May 21, 2004

Edwin I. Hatch Nuclear Plant
Joseph M. Farley Nuclear Plant
Vogtle Electric Generating Plant
Application for Technical Specification Amendment to
Eliminate Requirements for Hydrogen Recombiners and Hydrogen/Oxygen Monitors
Using the Consolidated Line Item Improvement Process

Enclosure 1: Basis for Proposed Change

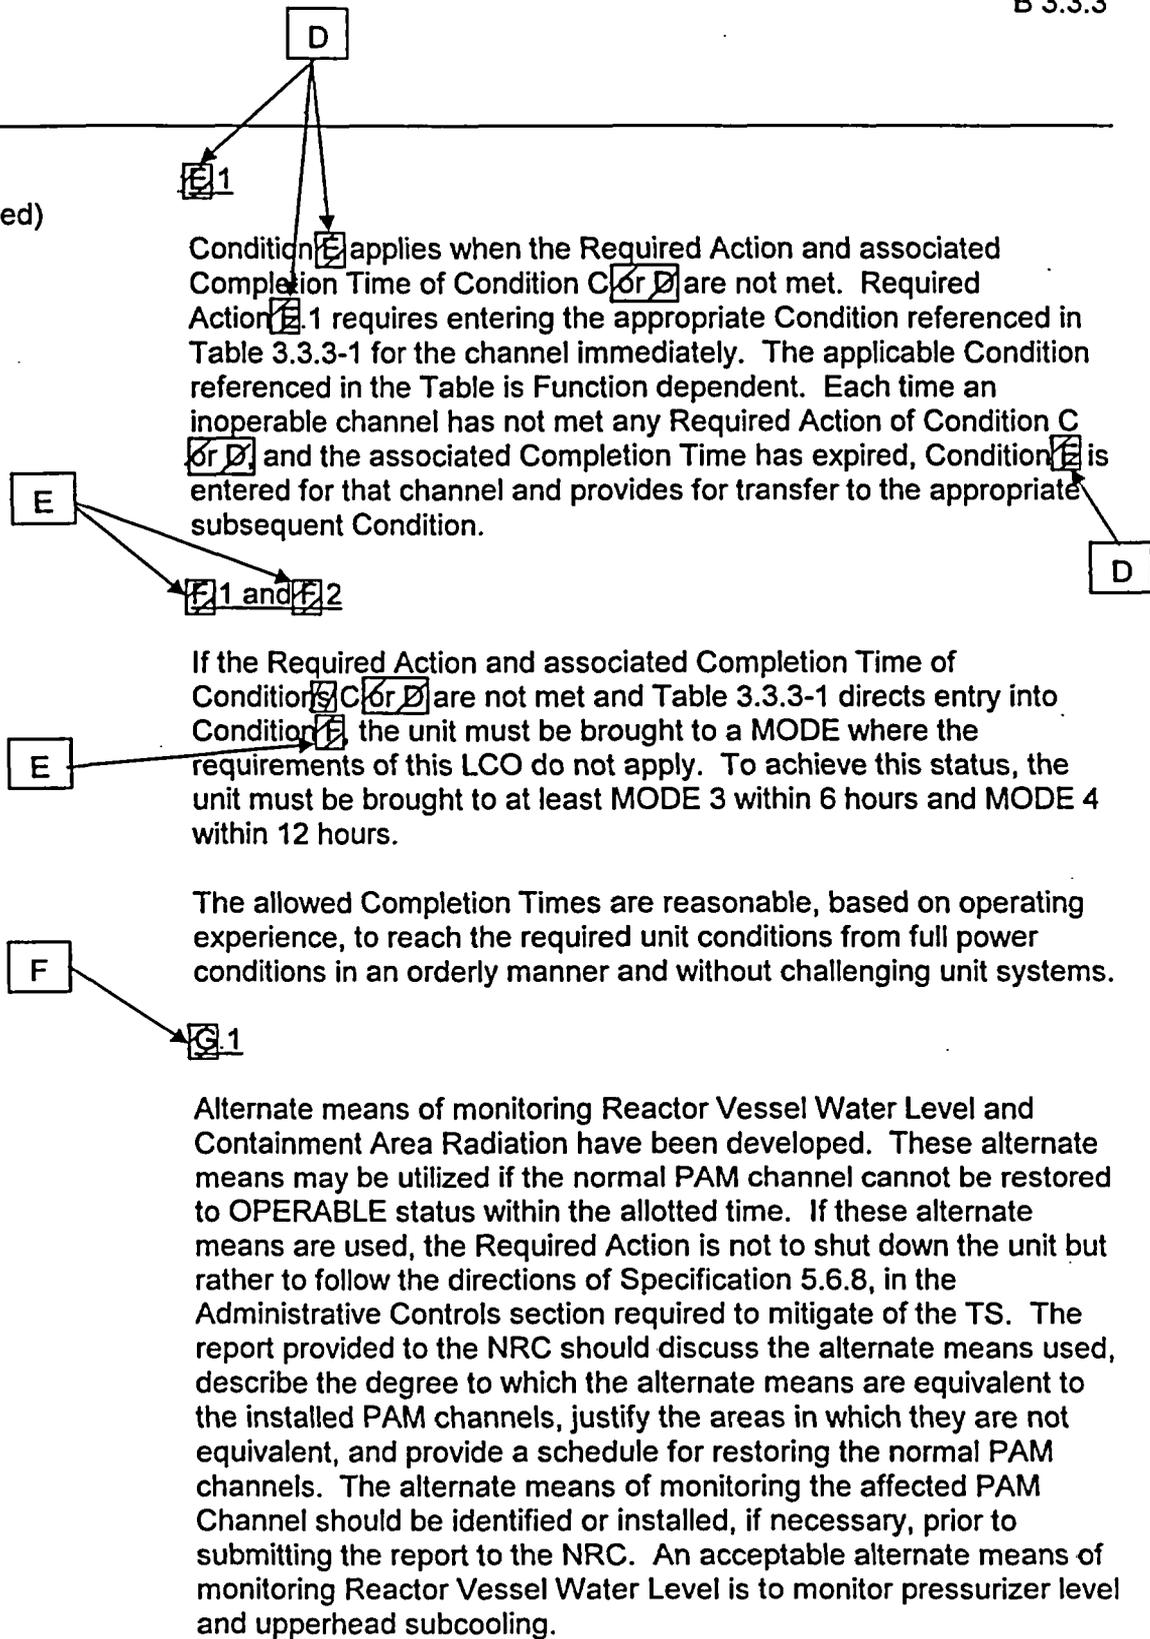
Condition C is modified by a Note that excludes hydrogen monitor channels.

Condition D applies when two hydrogen monitor channels are inoperable. Required Action D.1 requires restoring one hydrogen monitor channel to OPERABLE status within 72 hours. The 72 hour Completion Time is reasonable based on other core damage assessment capabilities available to provide information for operator decisions. Also, it is unlikely that a LOCA (which would cause core damage) would occur during this time.
